Subject: Product Change Notification for the EDS, PT, IKS, EDR, IEX, and EOM Series

Change Reason: The switching chip and/or power regulator and/or CPLD and/or flash memory used in the products below has been phased-out

Effective Date: May, 2017

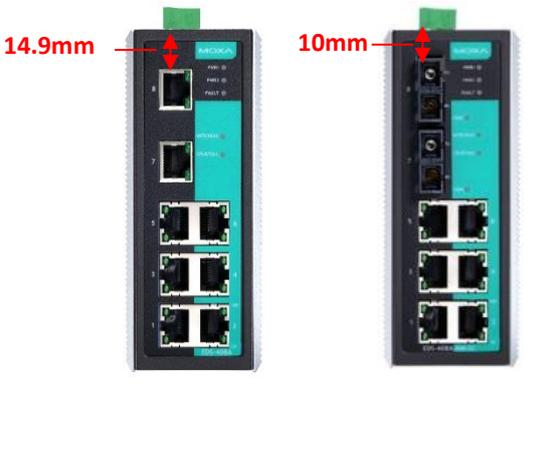
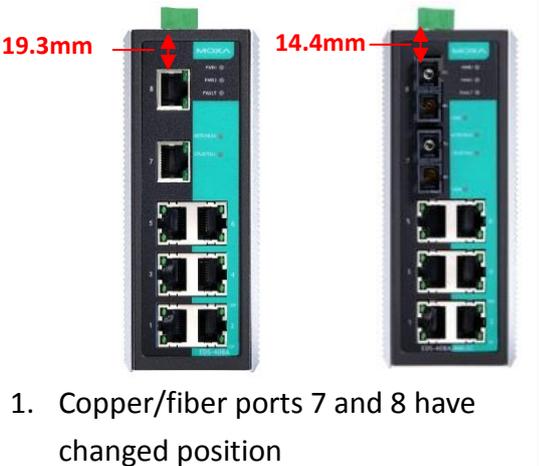
- Product specification change:
 - Add 12/48 VDC input voltage: EDS-405A Series, EDS-408A Series, and EDS-510A Series.
 - For EDS-405A/408A fiber model, ST connector material will change from metal to plastic.
 - EDS-405A/408A/510A Series will have an enhanced wall-mount kit, WK-46-01, to replace WK-46.
 - Product CD will be removed from the package in the new version.

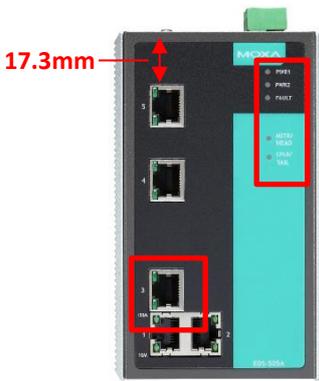
2. Product specification change:

- Add 12/48 VDC input voltage: EDS-505A Series and EDS-508A Series.
- For EDS-505A/508A fiber model, ST connector material will change from metal to plastic.
- EDS-505A/508A Series will have an enhanced wall-mount kit, WK-46-01, to replace WK-46.
- Product CD will be removed from the package in the new version.
